PCN Number:	PCN# 20251014001.2	**PCN Date:**	October 14, 2025

Title:	Qualification of CDAT as an additional Assembly/Test site for select devices

Sample product shipping label (not actual product label)

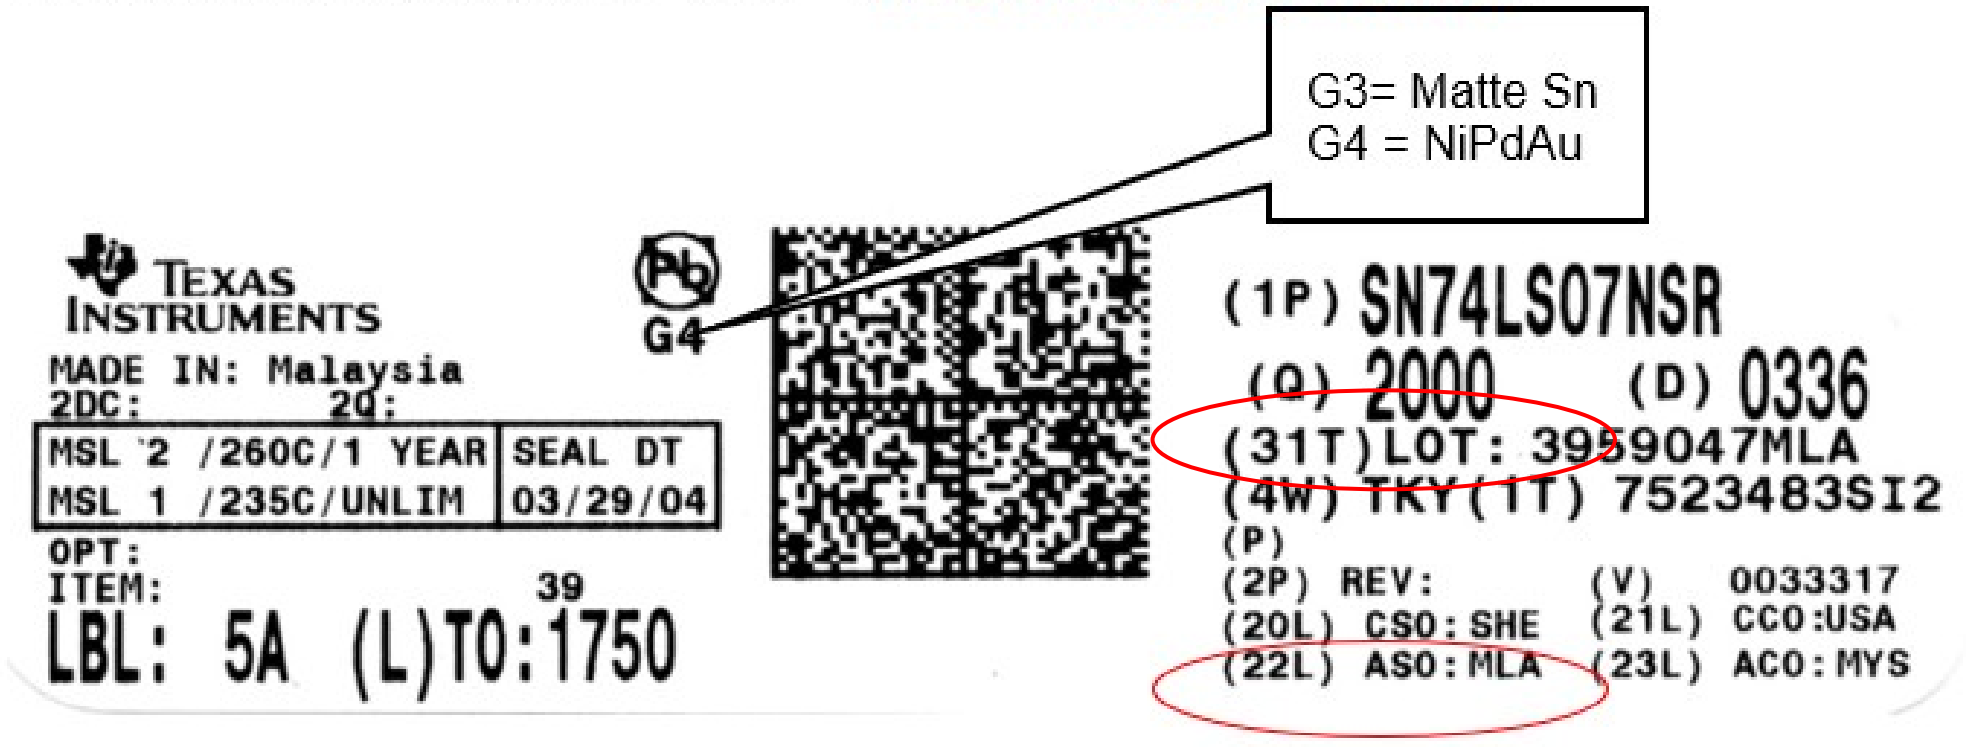
Changes to product identification resulting from this PCN:

Assembly Site	Assembly Site Origin (22L)	Assembly Country Code (23L)	Assembly City
HFTF	HFT	CHN	Hefei
HNA	HNT	THA	Ayutthaya
TFME	NFM	CHN	Economic Development Zone
CDAT	**CDA**	**CHN**	**Chengdu**

G3= Matte Sn
G4 = NiPdAu
